Addendum No.: 4

Date Of Addendum: 3/1/19

York Correctional Institution Central Plant and Piping Distribution

BI – JA – 465

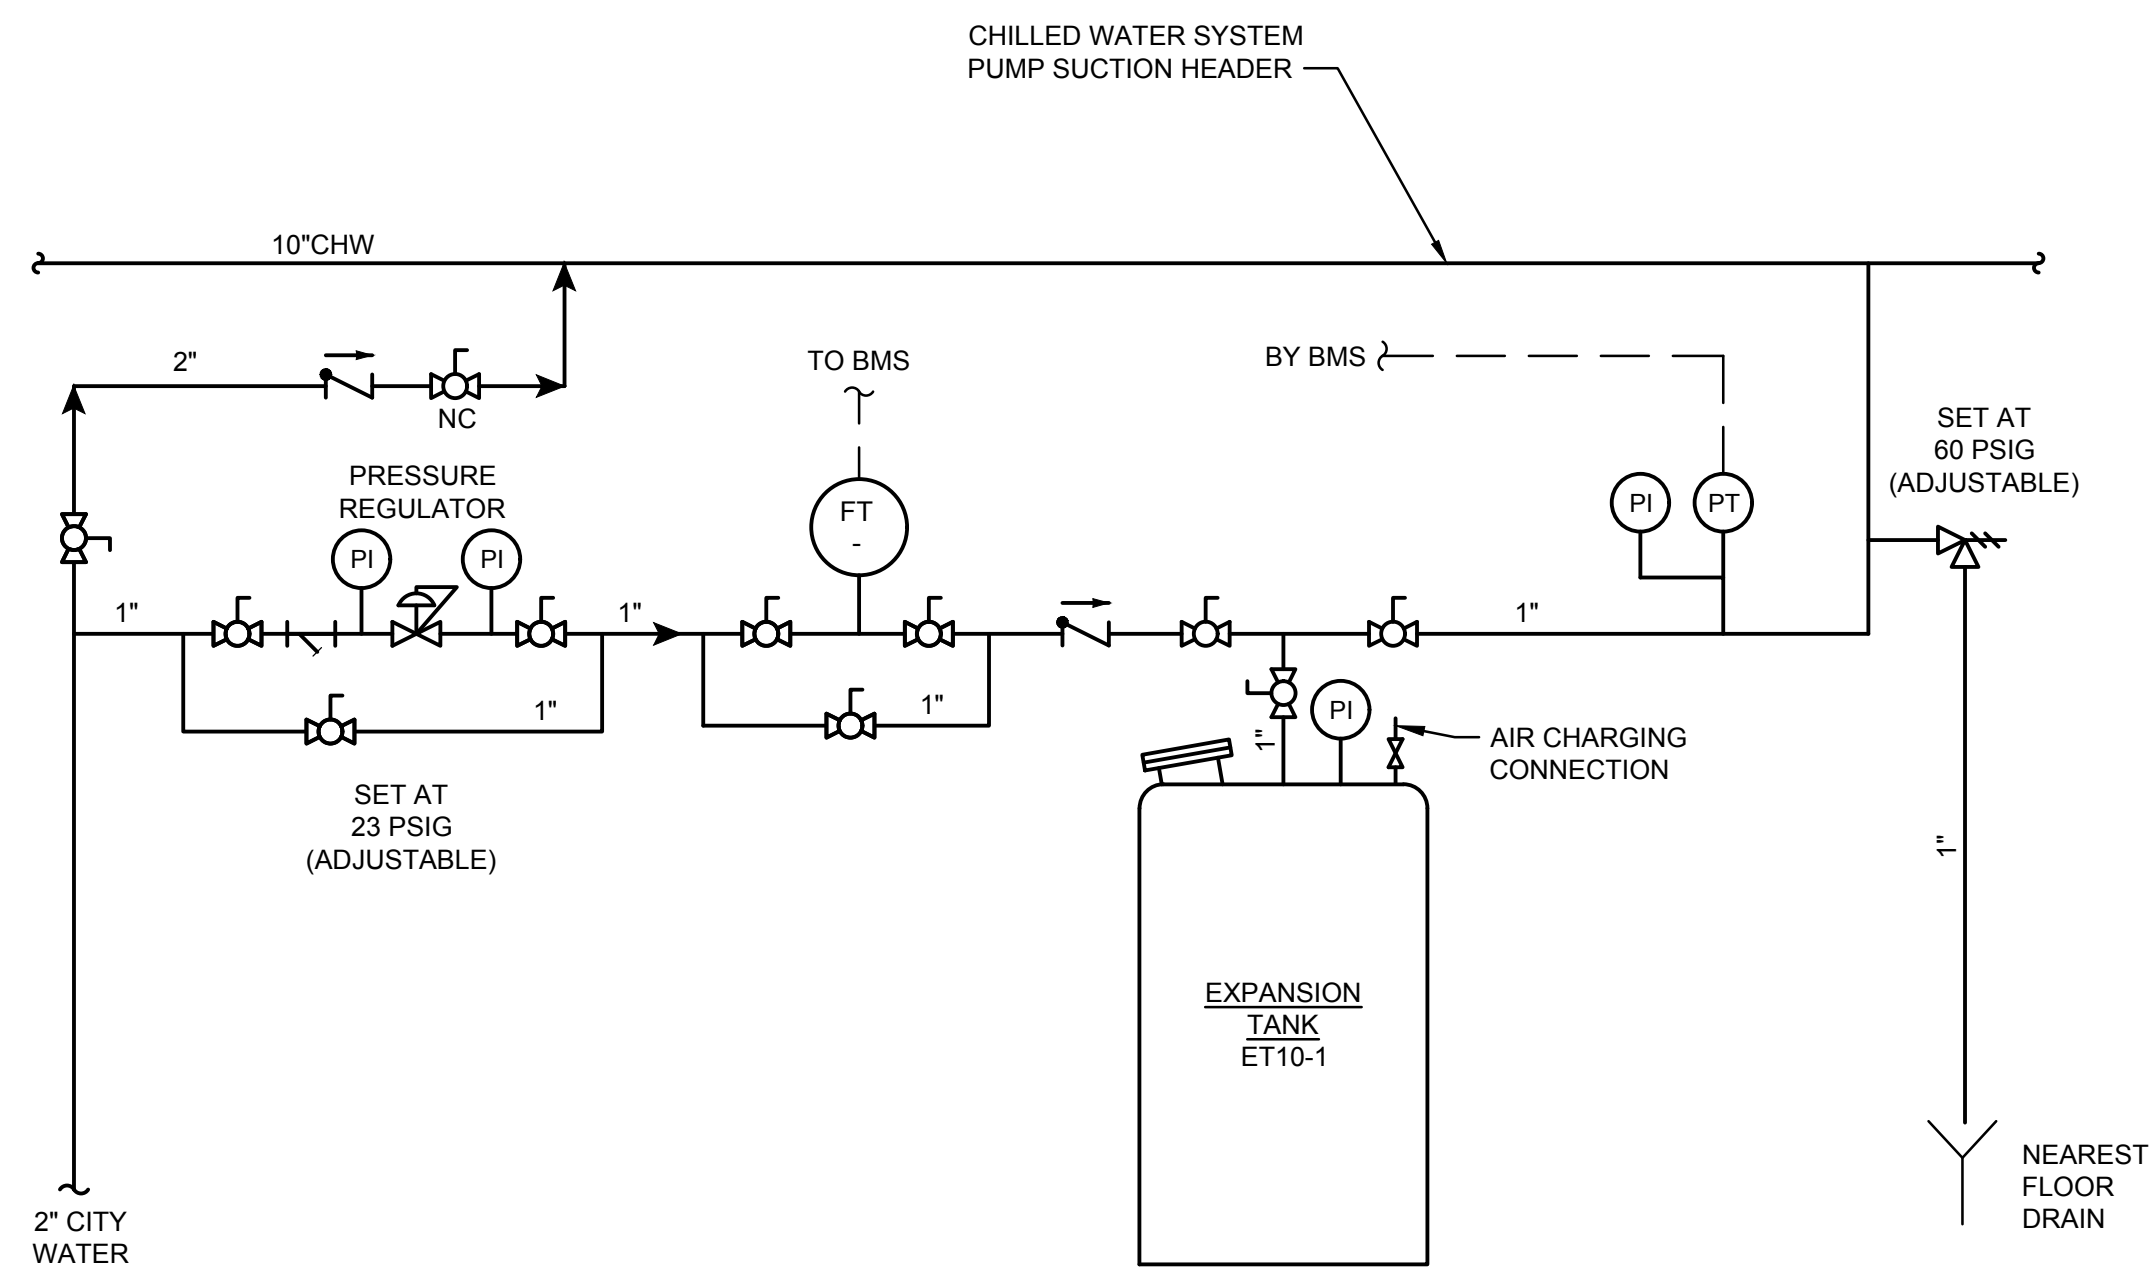
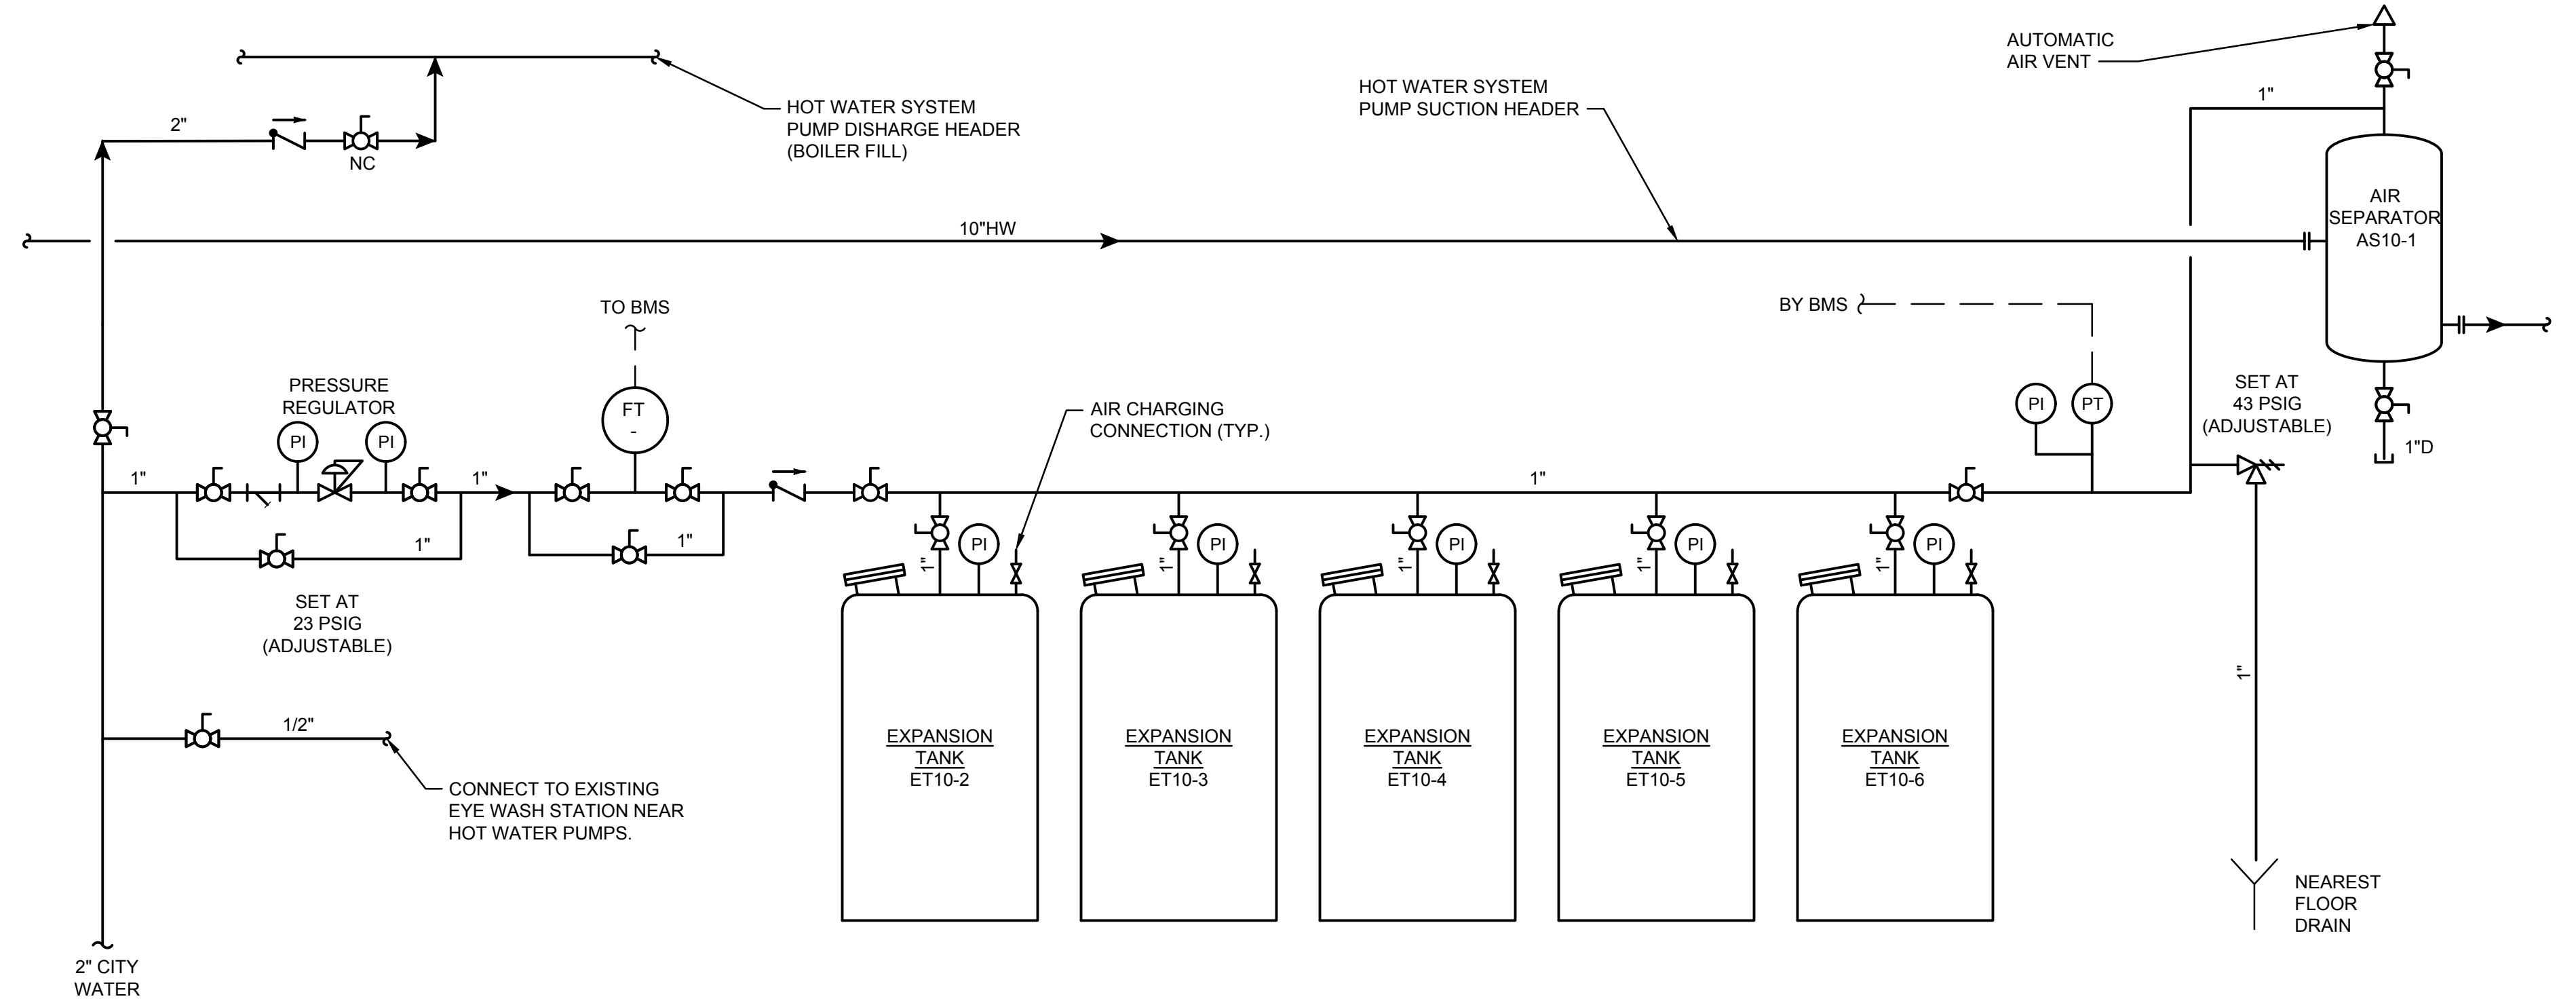
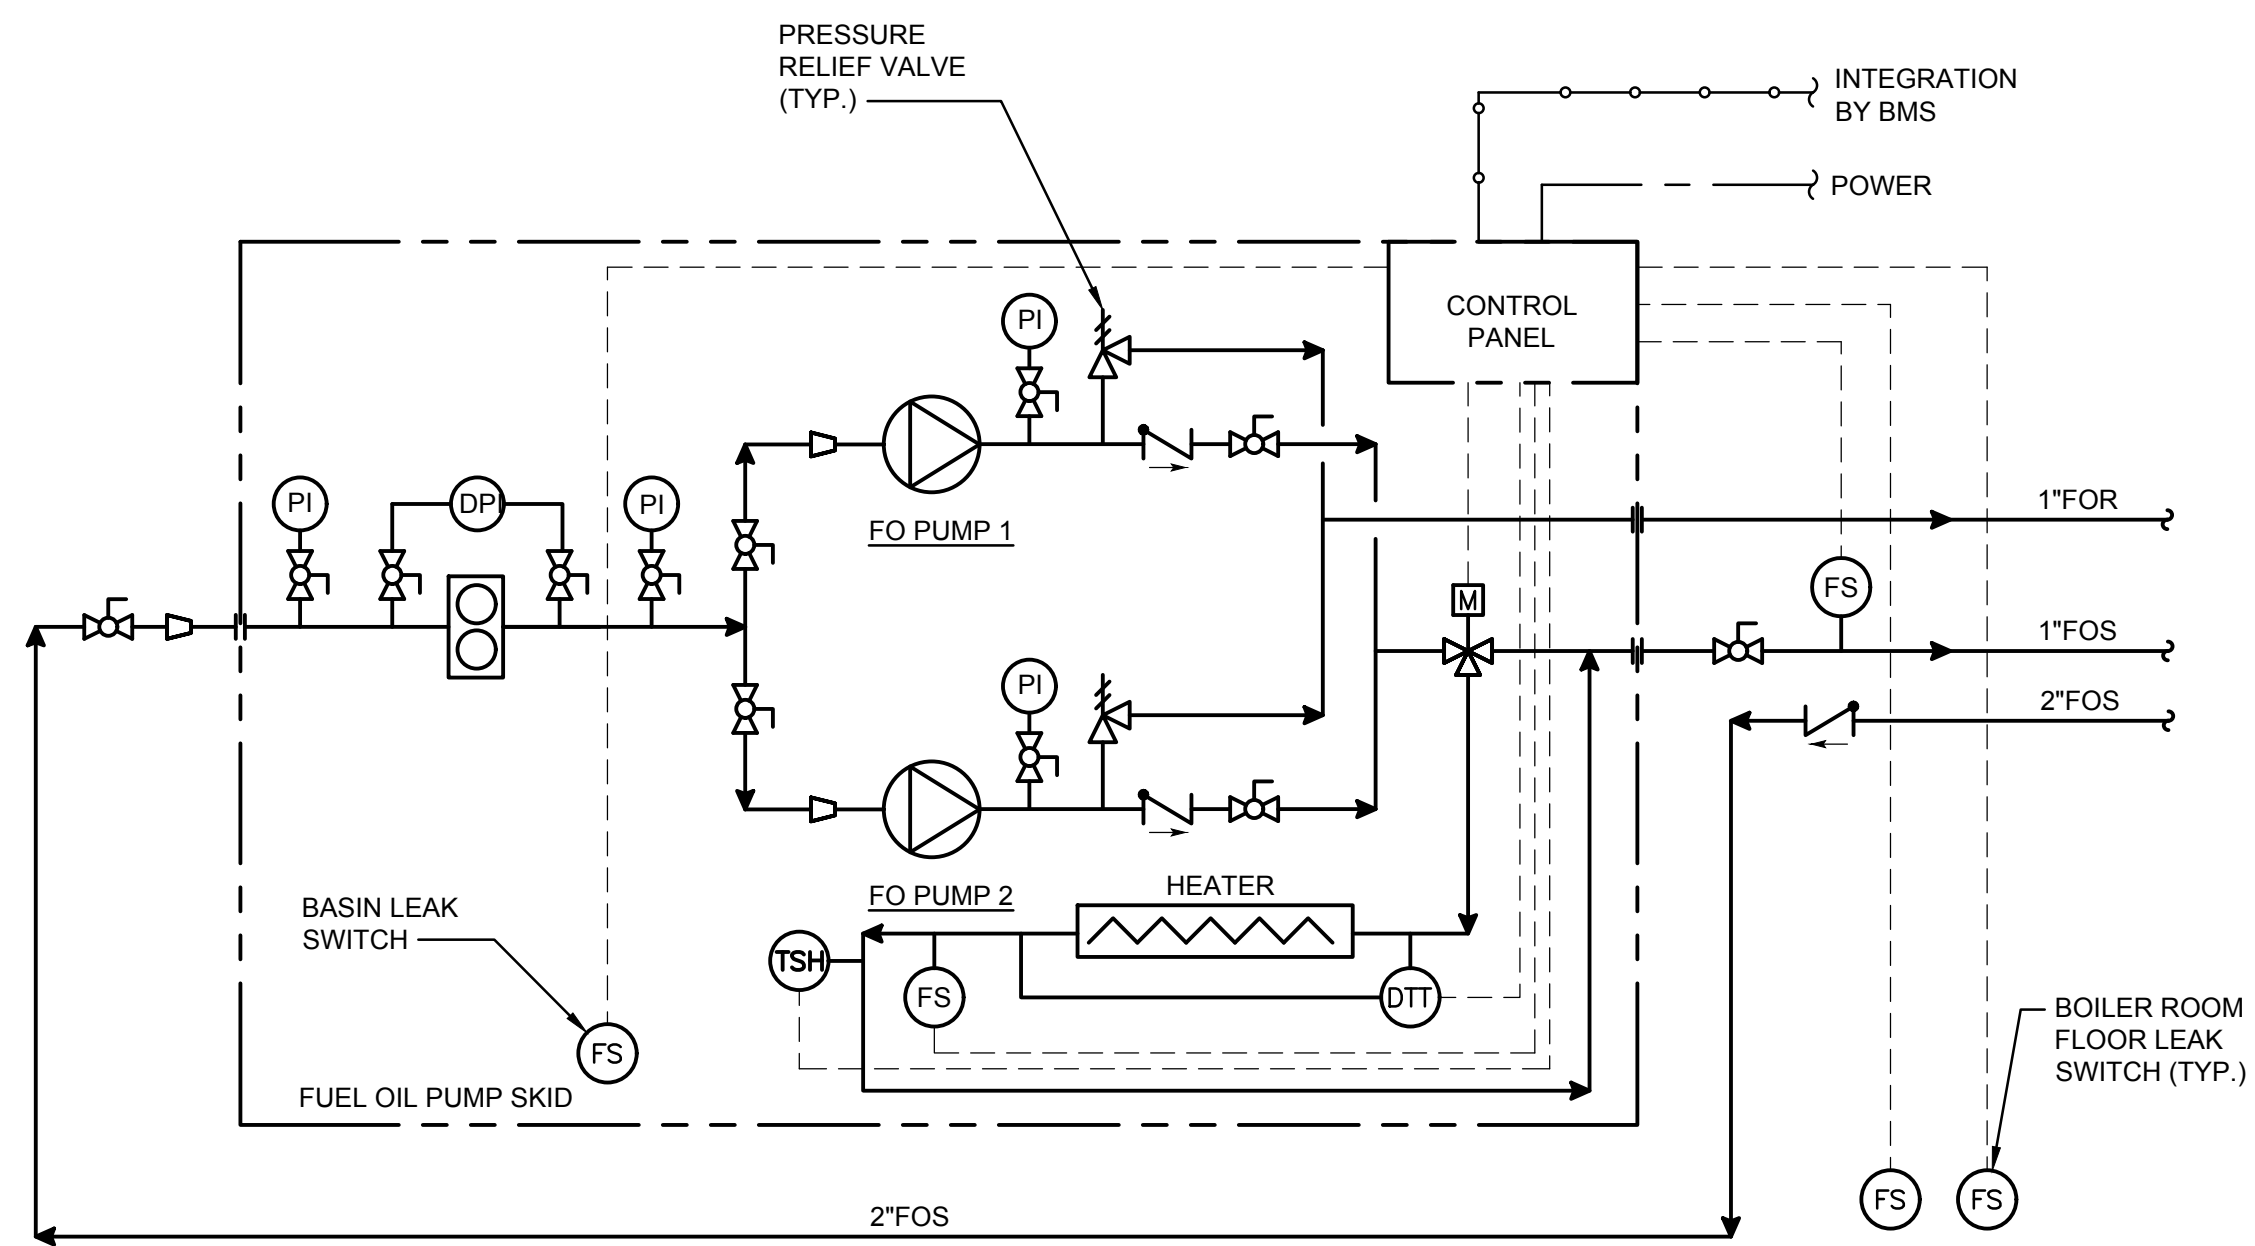
Drawing M903 Details - 4

UPDATED detail 5 in response to pre-bid questions Q84, Q85, and Q92.

- ***Q84: (23A) Is doghouse piping Detail 5/M903 required on 10" HW & 10" CHW at Building 10 Warehouse on M513?***

- ***Q85: (23A) Is doghouse piping Detail 5/M903 required on 10" HW & 10" CHW at Building 8 on M516?***

A84: No. For Building 10 doghouse the piping only passes through. Detail 5, Dwg M903 has been updated as part of this Addendum.

A85: No. For Building 8 doghouse the piping only passes through. Detail 5, Dwg M903 has been updated as part of this Addendum.

A92: Bypass piping shall be installed in building 0 doghouse only as noted in detail 5, dwg M903 which has been updated as part of this Addendum.
